# Technical Service Bulletin

<b>Subject:</b>  CHECK ENGINE LIGHT ON WITH DTC P2096:00	<b>Bulletin No.:</b> 01-011/19
	<b>Last Issued:</b> 07/24/2019

### PCM Identification

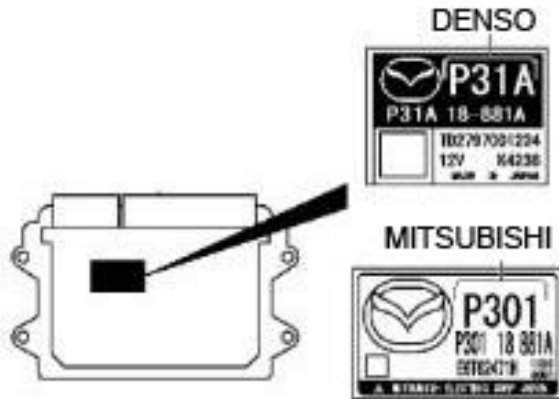
**NOTE:** This concern occurs only on vehicles with PCMs manufactured by MITSUBISHI.

Due to improper control logic of the PCM, a false error may be detected. To eliminate this concern, the PCM software has been modified.

1. Verify the customer concern.
2. Using the image above, verify the PCM in the subject vehicle is manufactured by MITSUBISHI, if yes, **read all cautions and notes below then proceed to "PCM REPROGRAMMING"**.
